DSOX3054A-01

S E R V I C E N O T E

DSOX3054A – Oscilloscope, Mixed Signal, 4 Channel,
500MHz

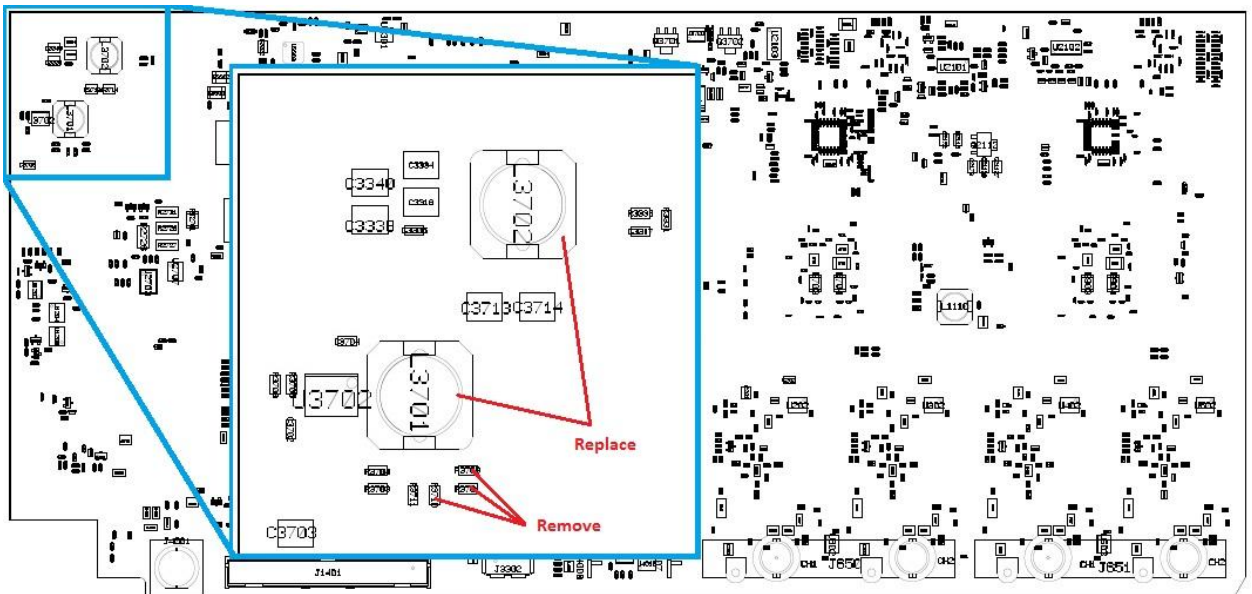
With the oscilloscope power turned on and while under normal operation, the unit emits a hissing noise.

2. As the picture indicates, remove the three resistors (0699-7209, 1 Ohm) located at R3701, R3709, and R3710. They are not to be replaced.
3. Remove as well the two inductors (9140-6474, 100uH) located at L3701 and L3702 and replace them with inductors with part number 9140-6151 (68 uH).
4. Re-assemble to the point where the unit could be powered up to verify that the hissing is indeed gone. If the hissing is not gone, please, check modifications.
5. When the hissing is gone, put oscilloscope back together.
